SUBJECT: Forwards responses to draft Chemical Engineering Branch
 SER open Items 146 & 147 re schematics of sample lines &
 panels (per TMI Item II.B.3) & post-accident sampling sys.

SHEARON HARRIS NUCLEAR POWER PLANT
UNIT NOS. 1 AND 2
DOCKET NOS. 50-400 AND 50-401
DRAFT SAFETY EVALUATION REPORT RESPONSES
CHEMICAL ENGINEERING BRANCH

DRAFT SER OPEN ITEM 146

FLOW DIAGRAM
 SAMPLING SYSTEM (NUCLEAR)
 FIGURE 9.3.2-1

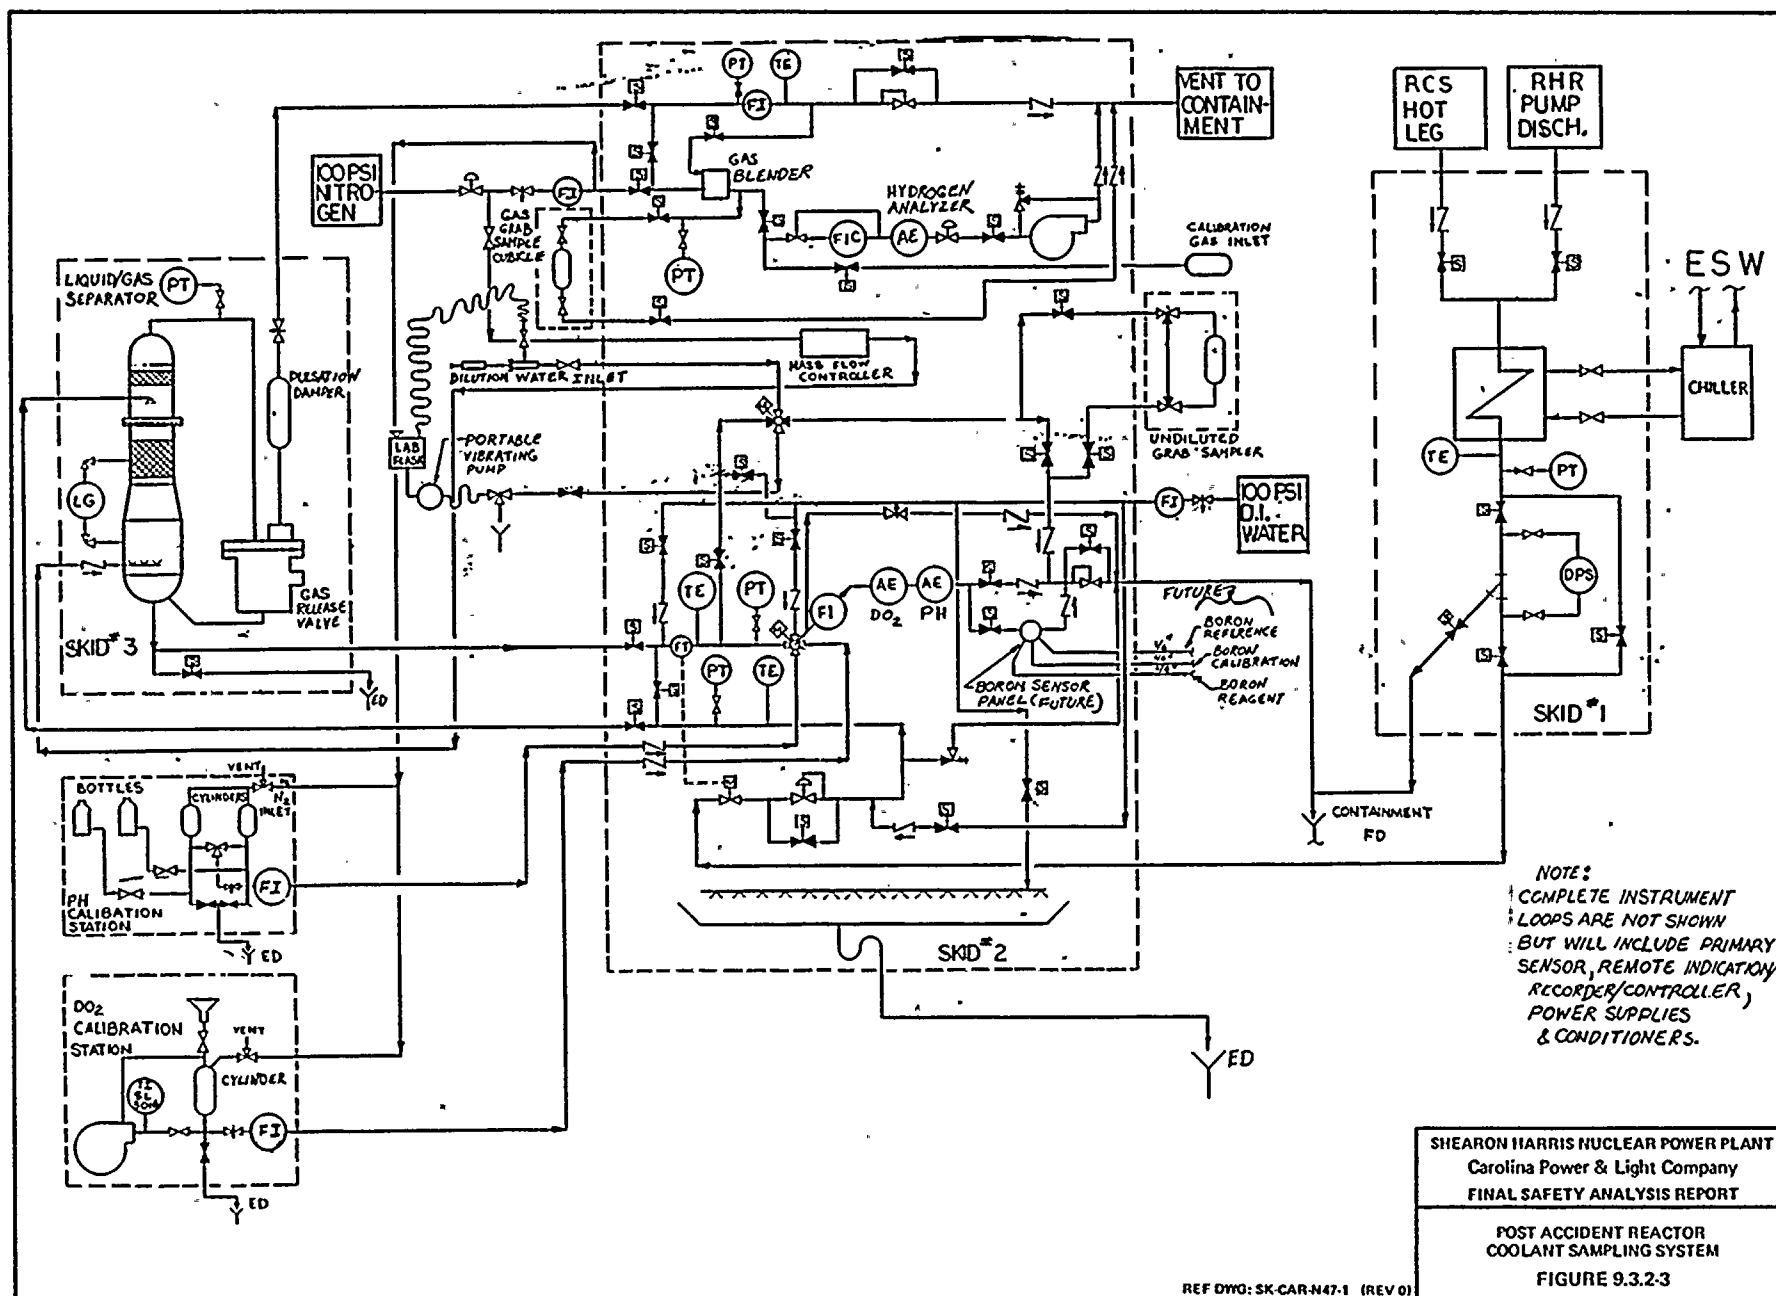
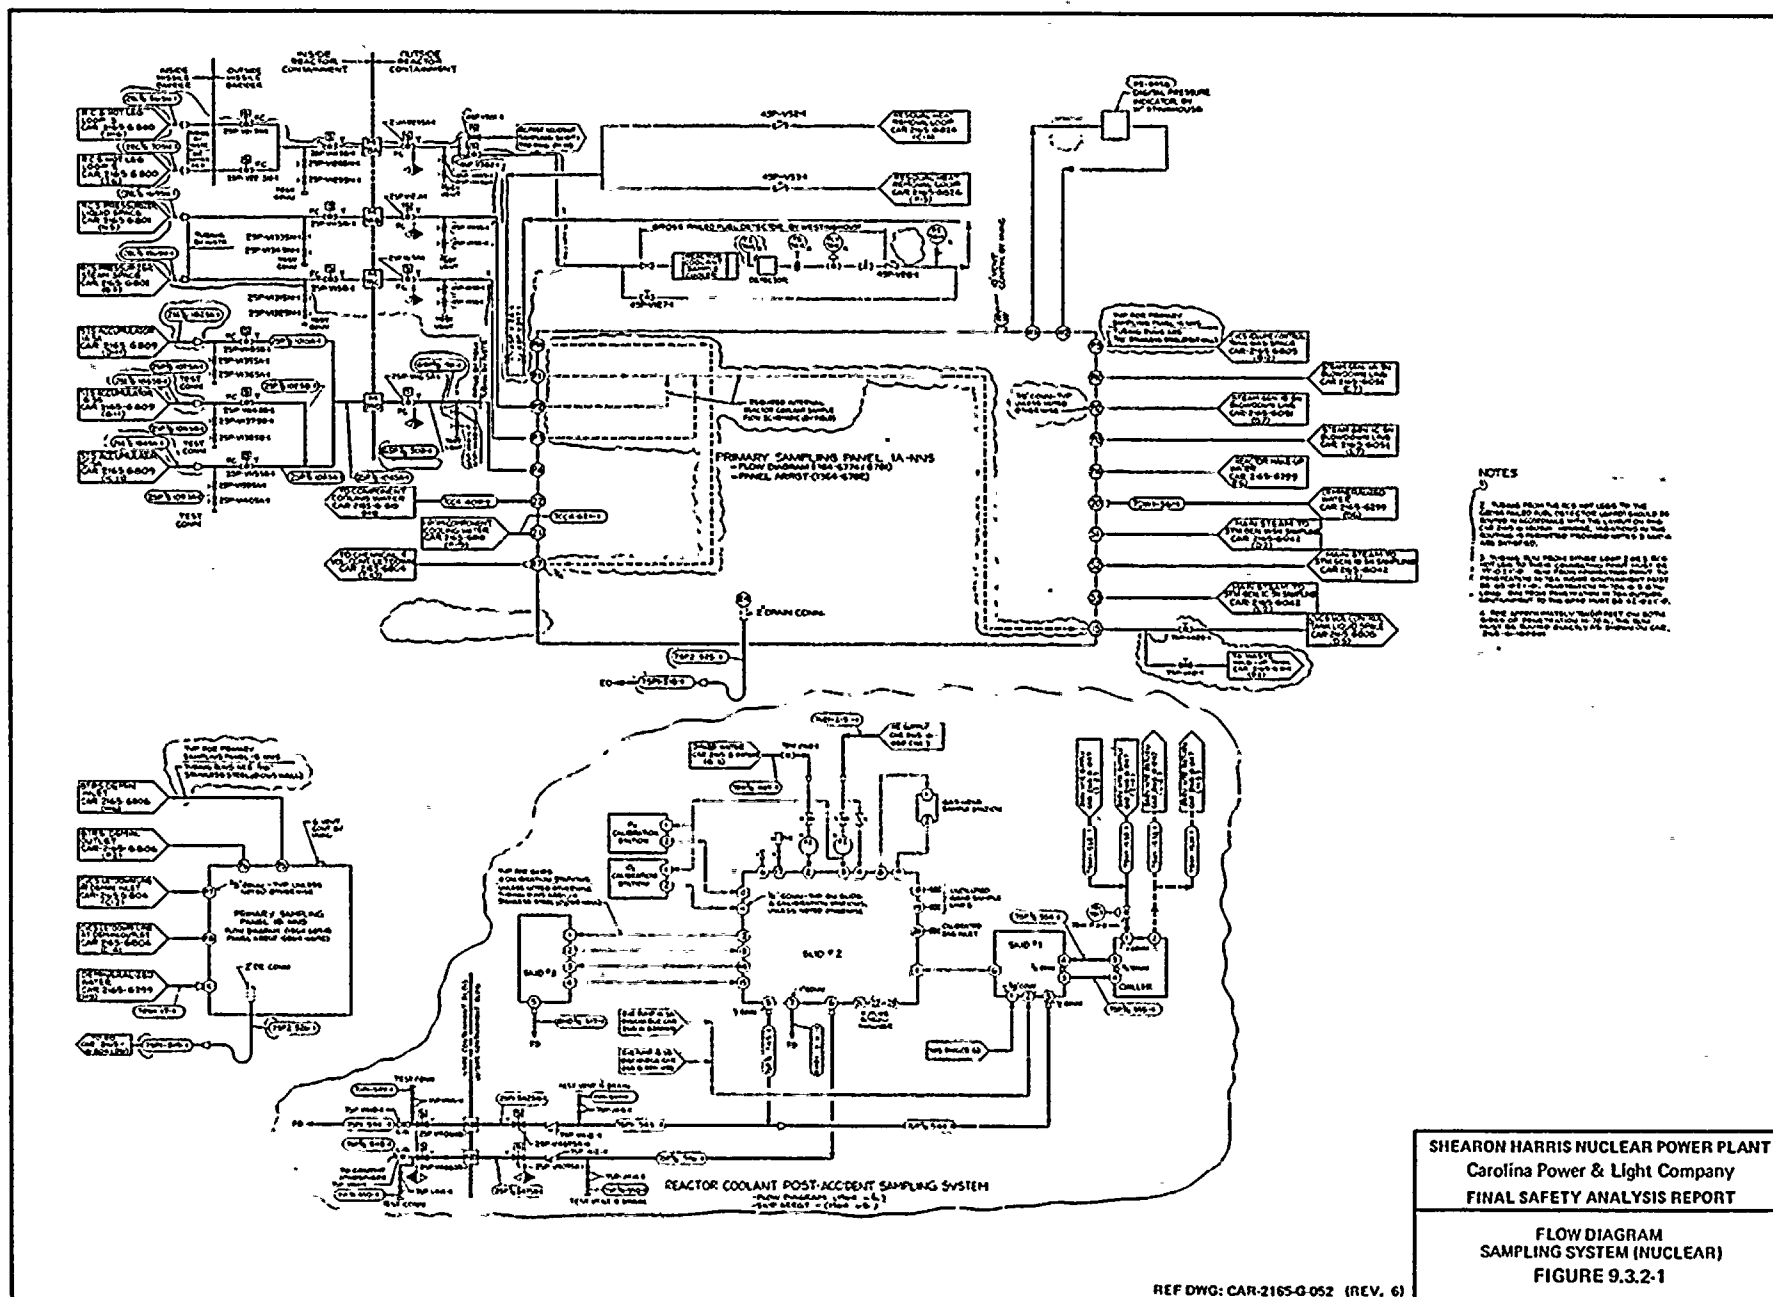
Provide the schematic diagrams of the sample lines and sampling panels.

Design criteria and capabilities of the Post Accident Sampling System comply with the guidelines of Item II.B.3 in NUREG 0737 and SRP 9.3.2 and are discussed in FSAR Section 9.3.2.2.3. The attached Figures 9.3.2-1 and 9.3.2-3 conceptually illustrate the sample lines and sampling panels, respectively.

FSAR Section 9.3.2.2.3 will be revised to provide final design information in a future amendment.
